Please find enclosed the revised version of the manuscript entitled "Models for Synchrophasor with Step Discontinuities in Magnitude and Phase: Estimation and Performance", IM-18-18517, authored by Marcelo Britto Martins, Renata de Barros e Vasconcellos, and Paulo A. A. Esquef, which was first submitted to TIM in July 2018.

Reviewer #1 (Required Remarks for the Author):

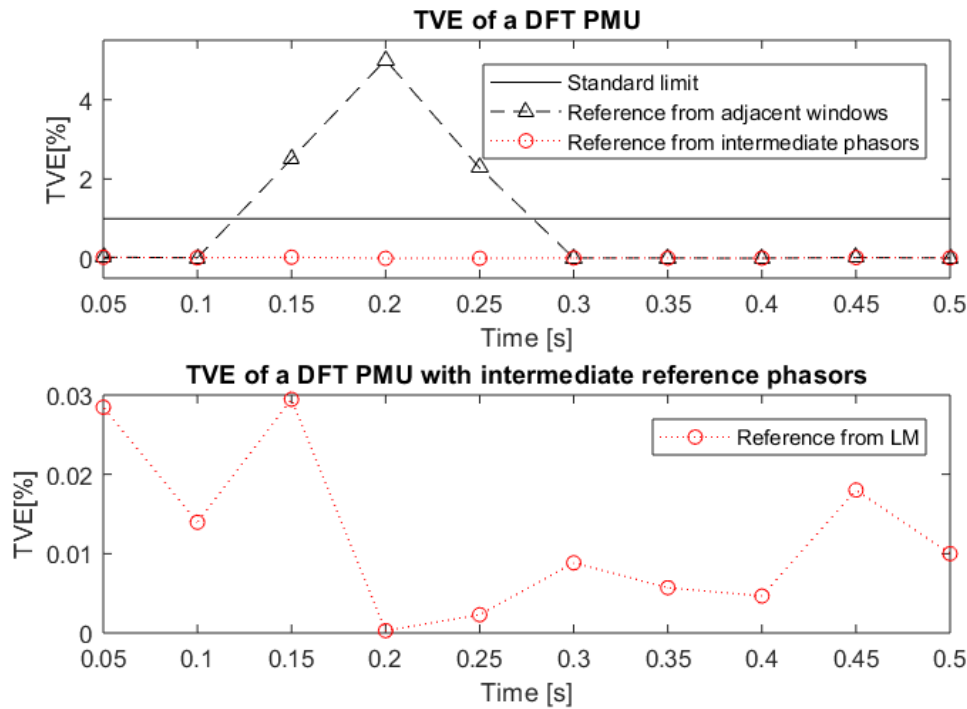
It is not clear what is the purpose or the benefit of using these intermediate values. How do they add to the calibration of the PMU?

Reference phasors are undefined when the observed phasor waveform has steps in magnitude or phase. Our purpose is to propose sensible and well-defined reference phasors in such situations, which can be used in the calculation of TVE and other related indicators. In previous works, reference phasors are simply obtained from adjacent windows with steady state signals, taken before or after the step occurrence, depending on its time location. This procedure depends on detecting with good accuracy the instant of occurrence τ , and is based on the assumption that the phasor measurements taken from adjacent windows are suitable estimates of the phasor in the window with a step. It should be noted that methods that use adjacent windows in the phasor estimate can be easily adapted to employ the models (4) and (5) of the intermediate phasors. We exemplify this in Section III.C (see Fig. 5) of the revised paper.

The standard prescribes step tests to measure the time response (TR), which is the time during which the TVE, FE or RFE exceeds the defined limit values. The calibration of P-class PMUs shall provide a very short TR (of the order of a few cycles).

We now report, in Section III.D. (see Fig. 6), additional computational simulations to show how the proposed intermediate phasor values affect the TVE estimates of a DFT-based PMU. For that, we calculated TVE estimates with two different methods:

- 1) The reference phasors obtained from the nearest adjacent window of 500 samples, as related in reference [4], with a Steady State estimator (SS). The value of τ is known a priori.
- 2) The reference phasors estimated by feeding our intermediate reference phasor models with values obtained by an LM estimator, using 1000 samples. The value of τ is known a priori.

The simulated DFT-based PMU receives a signal containing a positive 10% magnitude step, SNR = 50dB. The PMU window takes 1000 samples, with reporting rate of 20 frames/s.

The upper graph shows the TVE response of the DFT-PMU calculated with method 1 (black line), and method 2 (red line). The lower plot shows the TVE calculated with method 2 alone.

If one takes the TR from the TVE calculated with the phasor reference of method 1, it lasts about 250 ms. On the other side, with TVE calculated with the reference of method 2, the DFT-PMU never passes the standard limit. In the first case, this PMU would be rejected as a P-class, but in the second case not. It is the same PMU, the only difference is the definition of reference values for TVE. As TR is defined in function of TVE, this difference can be significative for the already standardized P-class PMU tests, as well as possible more stringent TR tests for distribution PMUs in the future.

We believe method 1 offers a phasor reference based on an observation window that is delayed w.r.t. that (containing the step) the DFT-PMU uses to produce its phasor output. This may explain the large measured TVE. On the other hand, both method 2 and the DFT-PMU use the same window (containing the step) to attain, respectively, the reference phasor and the measured phasor. Moreover, the intermediate reference phasor takes into account (in a weighted manner) the phasor states before and after the step. This seems to be a sensible choice that also confers a more stable and smooth phasor reference along time, despite the step transient. This behavior of the intermediate reference phasor may help reducing undesirable false detections in protection systems, based on TVE measures. From the above rationale, we are confident that our proposed intermediate phasor reference may be potentially useful not only for PMU calibration tests, but also for applications to protection systems.
